Analysis of Draft Tank Closure and Waste Management Environmental Impact Statement for Hanford Site, Richland Washington DOE/EIS-0391

David Bernhard
ERWM Program
Nez Perce Tribe
P.O. Box 365
Lapwai, ID 83540

February 16, 2010

Presentation Overview of ERWM Findings

Figure O-45. Concentration of Uranium-238 for Standard 10,000-Year Period

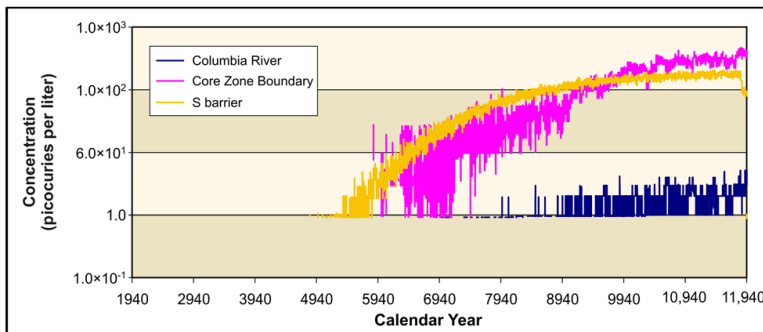
- Modeling of uranium did not show peak concentration in groundwater or river's edge water in 10,000 years.
- In appendix O modeling was extended to 30,000 years.
- Near site results (S Barrier) were similar for 10,000 and 30,000 years. Core and Columbia River were an order of magnitude higher for the 30,000 year run. This was not taken into account in any of the ecological or human long term hazard analysis.
- Appendix O assumes flux into the vadose zone was complete in 10,000 years for both the 10,000 and 30,000 year analysis. This is true for tank leaks, cribs or trenches. This would not be true for waste sites such as capped solid waste burial grounds. Flux would continue throughout the entire time frame allowing a significant portion of the total uranium to be released to groundwater and Columbia river.

<u>Standard (10,000 years)</u>	<u>Modified (30,000 years)</u>
Flux in = 2.97×10^1 curies	Flux in = 2.97×10^1 curies
Flux out = 1.05×10^1 curies	Flux out = 2.81×10^1 curies
Accumulated solute = 1.93×10^1 curies	Accumulated solute = 1.65 curies
Decay (percent) = 4.04×10^{-5}	Decay (percent) = 5.69×10^{-5}
Release to groundwater = 1.02×10^1 curies	Release to groundwater = 2.8×10^1 curies
Release to Columbia River = 2.83×10^0 curies	Release to Columbia River = 2.50×10^1 curies
S Barrier = 2.12×10^2 pCi, 393 ppb	S Barrier = 2.40×10^2 pCi, 445 ppb
Core Zone = 4.82×10^2 pCi, 893 ppb	Core Zone = 1.36×10^3 pCi, 2520 ppb
Columbia River = 5.05 pCi, 9.4 ppb	Columbia River = 1.52×10^1 pCi, 28.2 ppb

Appendix O With Site Uranium Taken Into Account

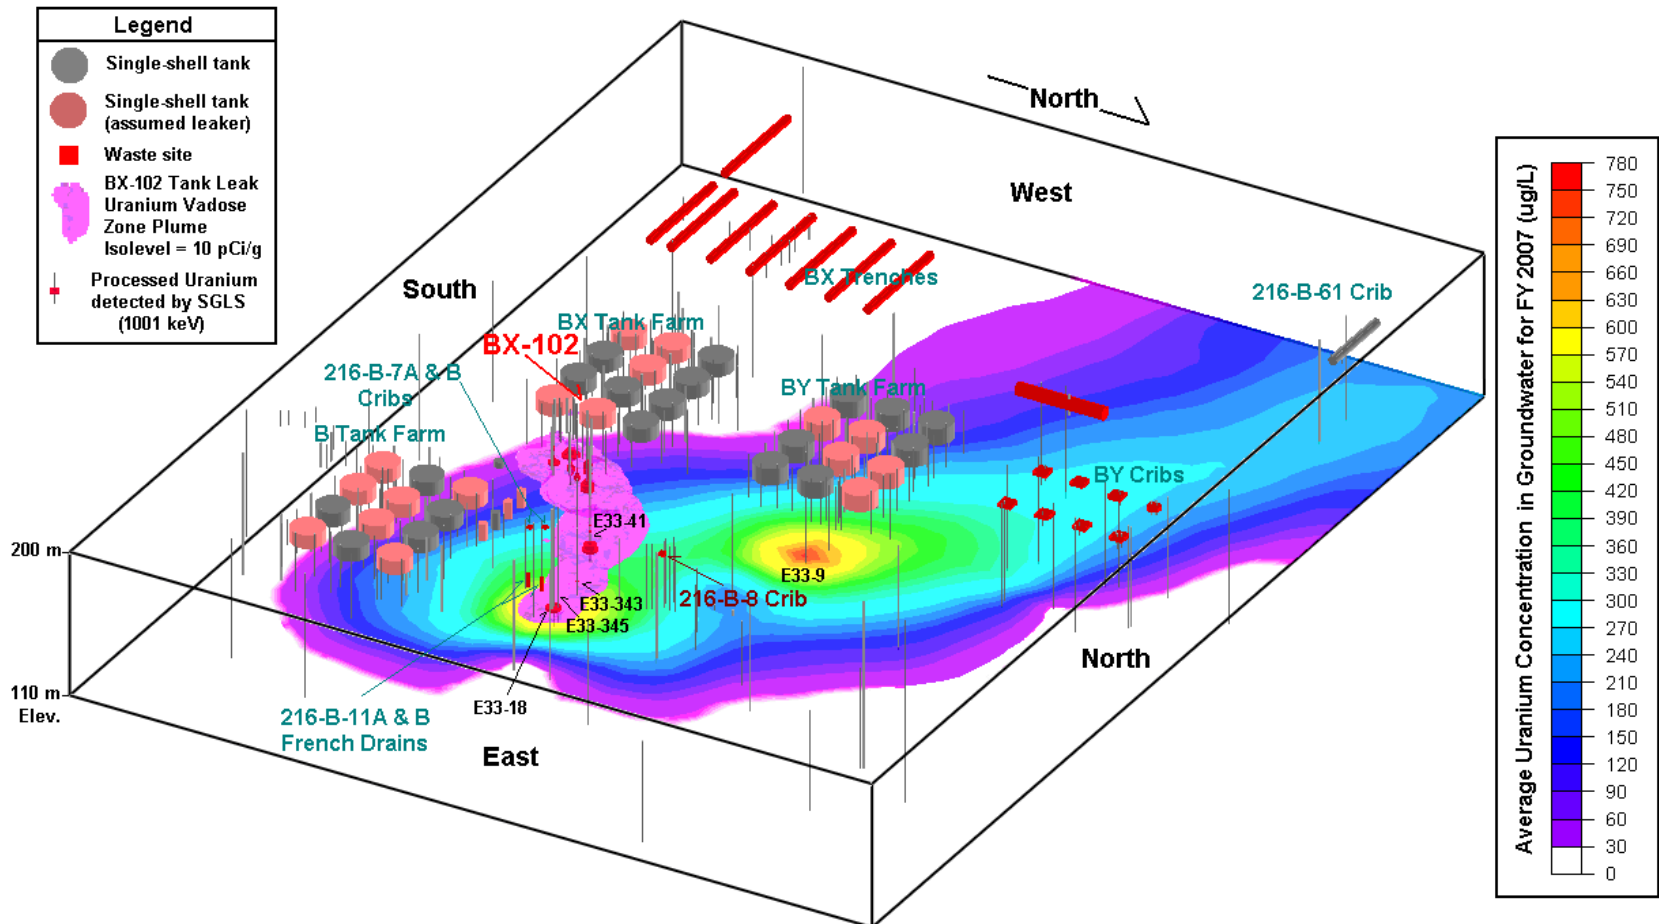
<u>Modified (30,000 years)</u>	<u>Modified (30,000 years) with All Uranium</u>
Flux in = 2.97×10^1 curies	Flux in = 1.80×10^3 curies (50% in 30k yrs)
Flux out = 2.81×10^1 curies	Flux out = 1.70×10^3 curies
Accumulated solute = 1.65 curies	Accumulated solute = 1.0×10^2 curies
Decay (percent) = 5.69×10^{-5}	Decay (percent) = 5.69×10^{-5}
Release to groundwater = 2.8×10^1 curies	Release to groundwater = 1.69×10^3 curies
Release to Columbia River = 2.50×10^1 curies	Release to Columbia River = 9.9×10^2 curies
S Barrier = 2.40×10^2 pCi, 445 ppb	S Barrier = approximately the same
Core Zone = 1.36×10^3 pCi, 2520 ppb	Core Zone = 5.38×10^4 pCi, 99700 ppb
Columbia River = 1.52×10^1 pCi, 28.2 ppb	Columbia River = 6.01×10^2 pCi, 1110 ppb

Assumes 50% released to mobile vadose in 30,000 years.

Assumes 33% reduction of amount Uranium reaching river in 30,000 years.

Even if the local U concentrations are much less the entire Hanford groundwater supply will be contaminated. This may last for 100,000 years.
